# Access Compliance Report Public Rights-of-Way (Curb Ramps)

Main Street: MARTHA\_ANN\_DR Cross Street: SHAKESPEARE\_DR Location: E

ADA ID: RPAT211201103949 Ramp Type: Type 1 - Perpendicular Diagonal Initial Pass/Fail: Fail Overall Compliance: No Severity Score: 15

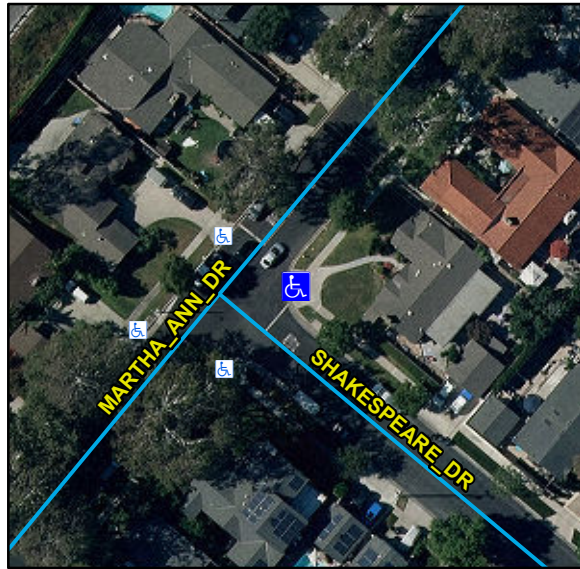
R304.2.2, STD 1115

| Compliance | Description                           | Data | Compliance | Description                   | Data |
|------------|---------------------------------------|------|------------|-------------------------------|------|
| No         | Ramp Run Slope (%)                    | 9.1  | N/A        | Flare Slope LT (%)            | N/A  |

Remove & Replace Curb Ramp With Two New Directional Ramps or Equivalent.
